Groundwater and Wastewater Services File Imaging Project

Re: Application for improvement permit for Richard Hagemeyer
Property Site: lot 8, Kalabash Road
Health Department file no. 4869B

SOIL/SITE EVALUATION
for ON-SITE WASTEWATER SYSTEM

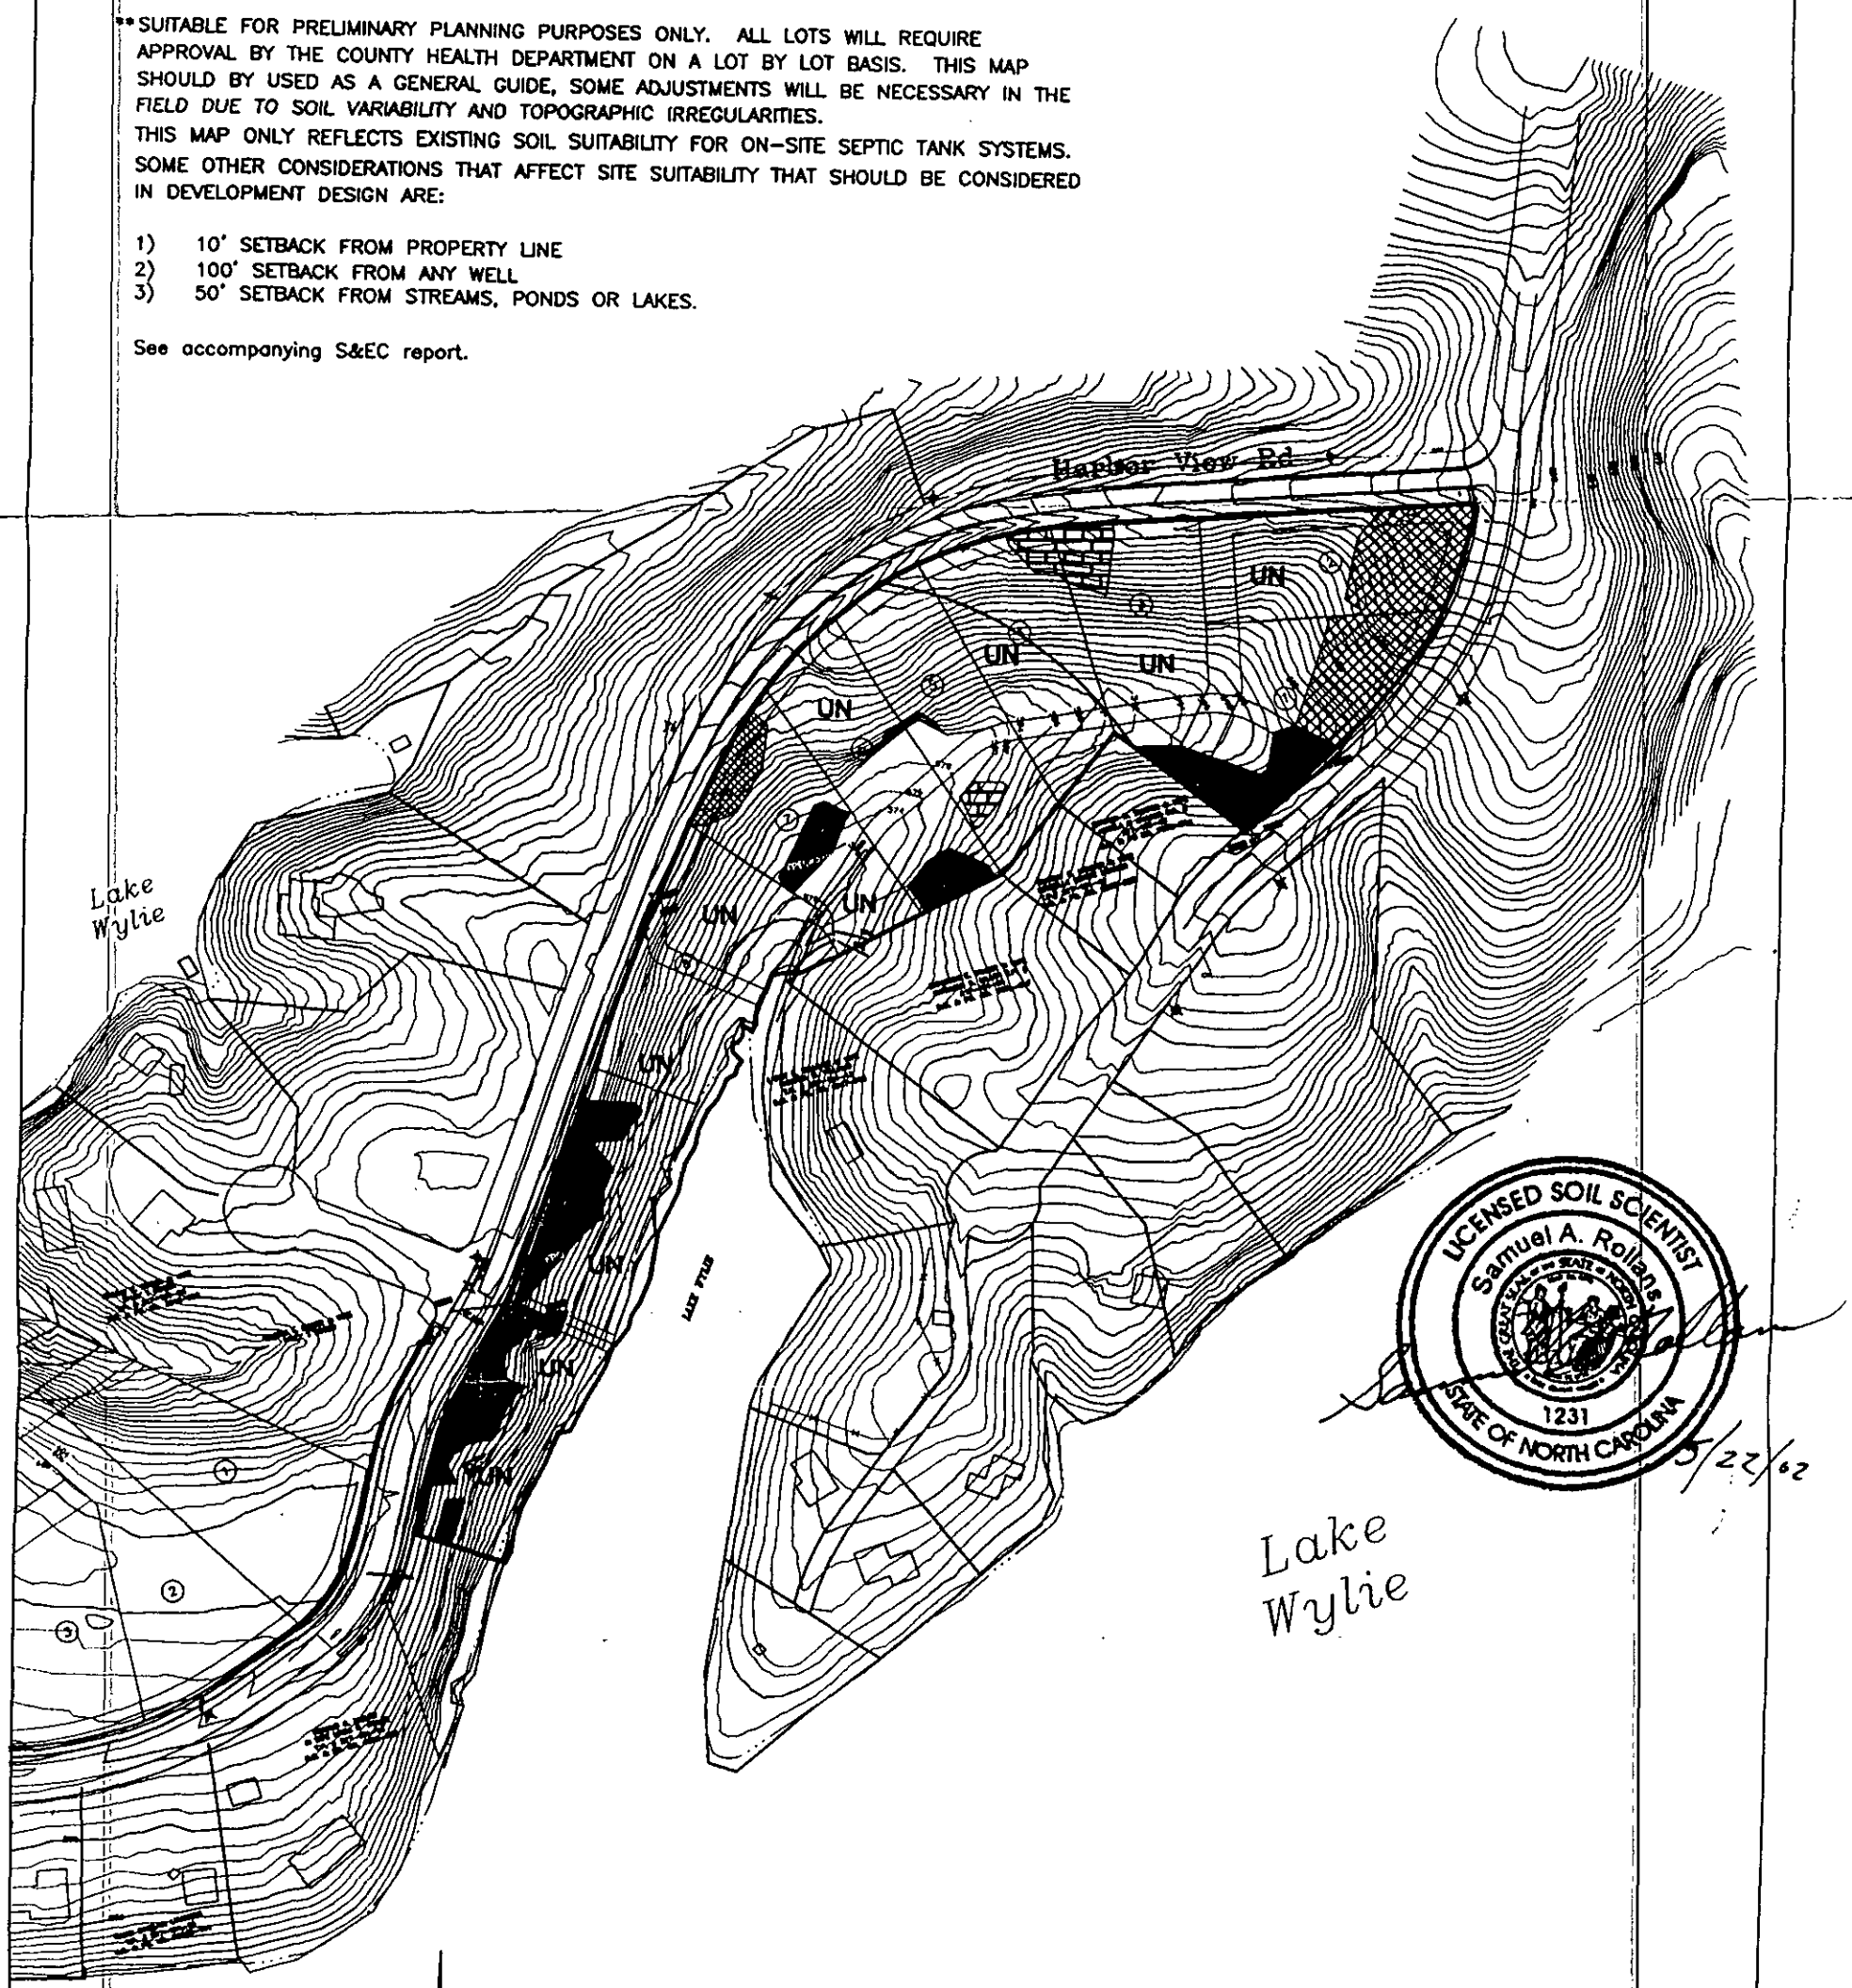
** SUITABLE FOR PRELIMINARY PLANNING PURPOSES ONLY. ALL LOTS WILL REQUIRE APPROVAL BY THE COUNTY HEALTH DEPARTMENT ON A LOT BY LOT BASIS. THIS MAP SHOULD BY USED AS A GENERAL GUIDE, SOME ADJUSTMENTS WILL BE NECESSARY IN THE *FIELD DUE TO SOIL VARIABILITY* AND TOPOGRAPHIC IRREGULARITIES.
THIS MAP ONLY REFLECTS EXISTING SOIL SUITABILITY FOR ON-SITE SEPTIC TANK SYSTEMS. SOME OTHER CONSIDERATIONS THAT AFFECT SITE SUITABILITY THAT SHOULD BE CONSIDERED IN DEVELOPMENT DESIGN ARE:

1) 10' SETBACK FROM PROPERTY LINE
2) 100' SETBACK FROM ANY WELL
3) 50' SETBACK FROM STREAMS, PONDS OR LAKES.

PROPOSED PLOT PLAN

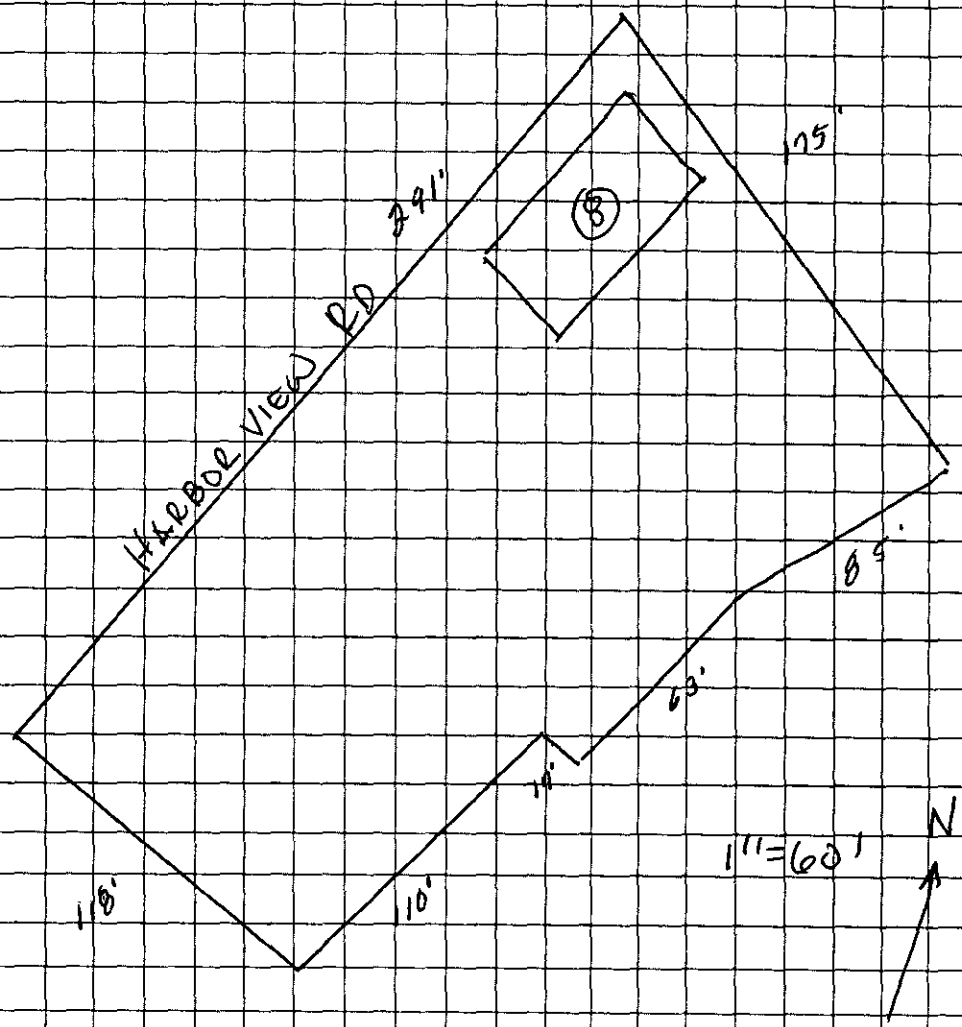
Based on the criteria set out in Title 15A, Subchapter 18A, of the North Carolina Administrative Code. Rules .1940 through .1948, the evaluation indicated that the site is **UNSUITABLE for** a ground absorption sewage system. Therefore, your request for an improvement permit is **DENIED.** A copy of the site evaluation is enclosed. The site is unsuitable based on the following:

____X___Unsuitable soil topography and/or landscape position (Rule .1940)
_____Unsuitable soil characteristics (structure or clay mineralogy) (Rule .1941)
_____Unsuitable soil wetness condition (Rule .1942)
_____Unsuitable soil depth (Rule .1943)
_____Presence of restrictive horizon (Rule .1944)
____X____Insufficient space for septic system and repair area (Rule .1945)
____X____Unsuitable for meeting required setbacks (Rule .1950)
_____Other (Rule .1946)
